SUBJECT: Transmittal of Westinghouse Responses to US NRC Requests for Additional Information on the AP1000 Application for Design Certification

**Westinghouse Non-Proprietary Response to US Nuclear Regulatory Commission
Requests for Additional Information dated April 2003**

AP1000 DESIGN CERTIFICATION REVIEW

Figure 650.004-1 AP1000 IRWST Plan View

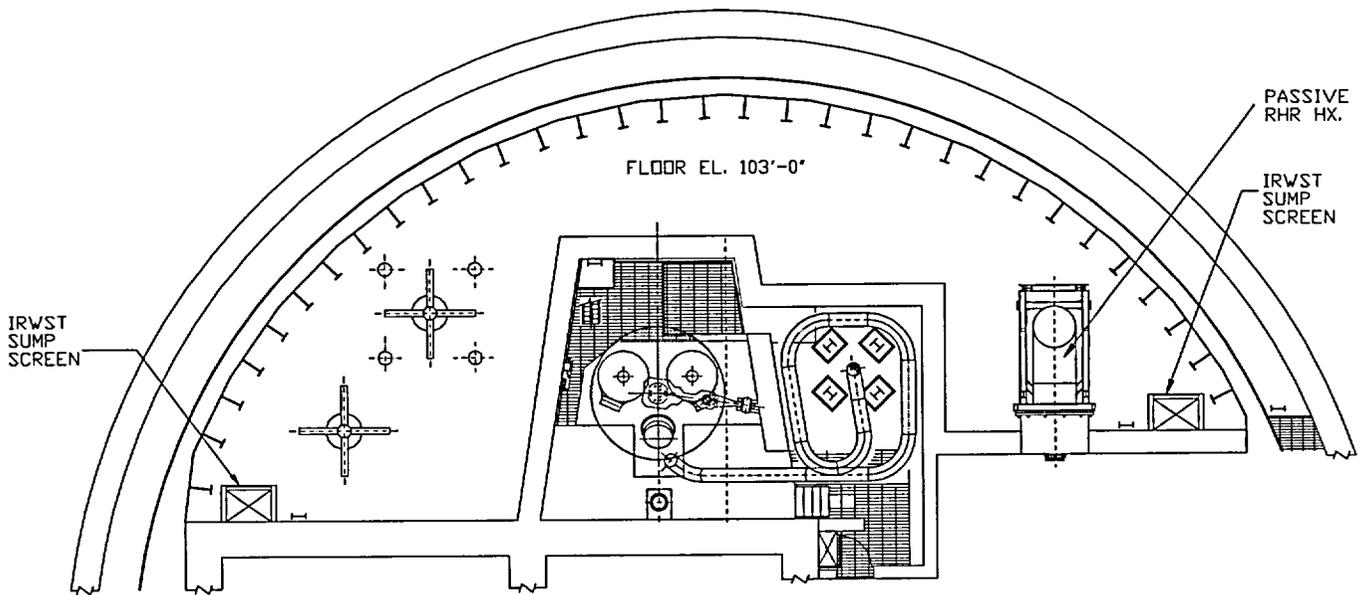
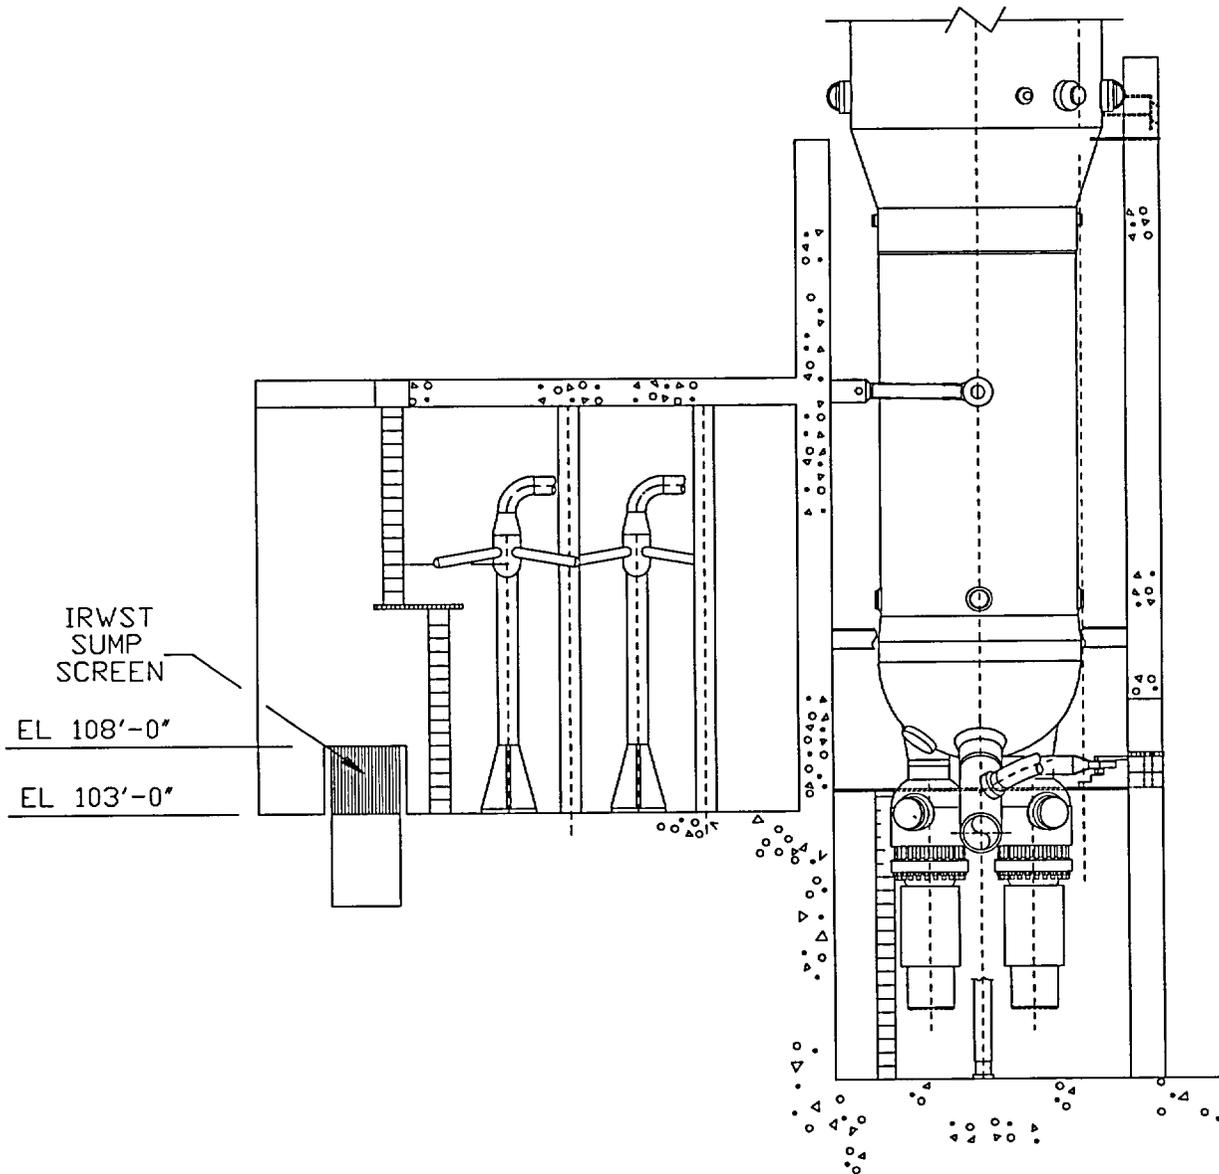
What is the basis for the conclusion in the RAI response that ". . . any resident debris that might have settled on the IRWST floor prior to an accident is not likely to be stirred up by the ADS . . . ?" That is, what sort of analysis has been done to demonstrate that the turbulence conditions within the IRWST are sufficiently low at the floor of the tank during an ADS actuation?

The IRWST is a stainless steel lined storage tank located inside containment. Refer to Figure 650.004-1 and -2. The tank is normally closed off from the containment although there are large louvered vents located through the IRWST roof. The tank is 30.25 feet high (inside floor to ceiling). The tank extends around part of the containment from the refueling cavity past the pressurizer and is about 120 feet across. There are two ADS spargers located in one side of the tank. The bottom of the sparger arms are located about 16 feet above the floor of the tank. There are two separate PXS injection line connections from the bottom of the IRWST. Line A is on the ADS side and line B is on the other side with the PRHR HX. Each of these lines is protected by a screen assembly. Line A has a connection to the Spent Fuel Pool Cooling System (SFS) pumps. This line allows the SFS to recirculate the water in the IRWST to provide

As discussed above significant quantities of debris are not expected to settle out in the IRWST during normal operations. Even if such debris ~~did~~ were to have settled onto the IRWST floor, they are ~~it~~ is not expected to be stirred up in the limiting accident. **The basis for this statement is the discussion of the ADS design and plant behavior presented below and the observation of test results from the Low-Pressure Integral Systems Test at Oregon State University. OSU has a scaled ADS sparger. OSU test SB-12 is a DVI LOCA; it shows that the temperature near the bottom of the IRWST (below the PRHR HX bottom) shows essentially no temperature change out through ADS 4 actuation (Reference 1). Although this test was performed for AP600, the design of the IRWST, the ADS sparger and ADS stages 1, 2, 3 have not been changed for AP1000. As a result, the conclusions also apply to the AP1000.**

Figure 650.006-1 AP1000 Coating Debris Settling (Front)

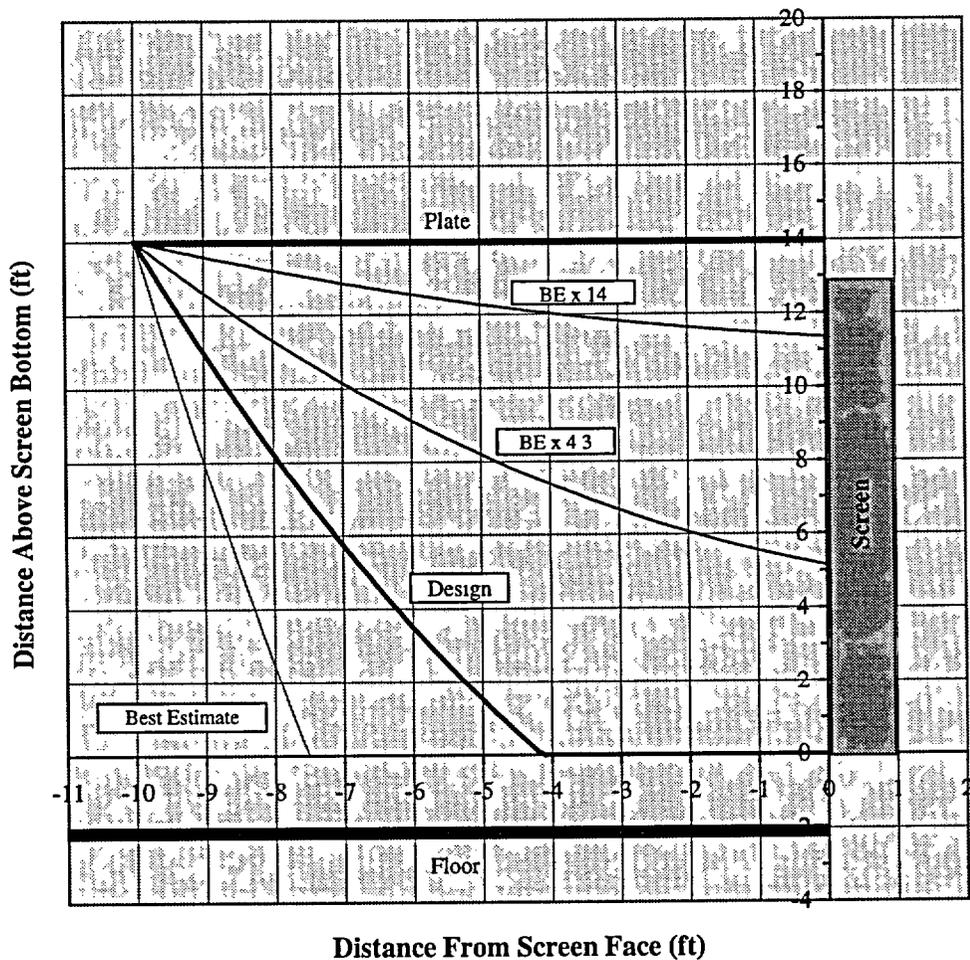
What is the basis for using 200 mils as the diameter for postulated coating debris? Experience shows that much smaller flakes are possible, and smaller flakes would tend to settle more slowly than would the larger diameter flakes assumed in the calculation, presenting a potentially greater challenge to the sump screen. When potential resident fiber loadings are considered, flakes significantly smaller in diameter than 200 mils are presumably large enough to become trapped at the interstitial locations of the lattice formed by a fibrous debris bed. Although they presumably represent particles smaller than 200 mils, it is not clear exactly what flake sizes correspond to the bounding settling calculations (i.e., B.E. x 4.3, B.E. x 14), and thus it is not clear what degree of conservatism is being employed when considering the sizes of flakes that can be generated through known failure mechanisms.

Figures 650.006-1 and -2 show the settling trajectories of coating debris starting at the edge of the protective plate. Figure 650.006-1 shows the approach from the front of the screen and figure 650.006-2 shows the approach from the side. Such debris can not enter the water any closer to the screens because no coatings are permitted any closer to the screens. The figure shows that with design settling rates the debris will settle to the elevation of the bottom of the screen after drifting about 6 feet, which is at about 4 feet away from the screen. Significant conservatism was included in this evaluation, including assuming the lightest/smallest coating debris. **The minimum debris size was selected as a disc 200 mils in diameter and 5 mils thick. The 200 mils was selected as the smallest size that**

It also assumes the maximum recirculation flow of 1600 gpm, consistent with the maximum flow from two RNS pump operating unthrottled with suction taken from two screens. Another area where significant margin has been applied is in the debris settling rates. AP1000 uses debris settling rates that contain a factor of two margin compared to the reference settling data (Reference 1) which is sufficient to account for uncertainties. Without this added margin, the coating debris settles out very quickly in less than 3 feet, as shown in Figure 650.006-1 and -2.

The debris settling shown in figures 650.006-1 and -2 provide confidence that the plant can sustain complete failure of the nonsafety-related coatings located inside containment without excessive blockage of the recirculation screens.
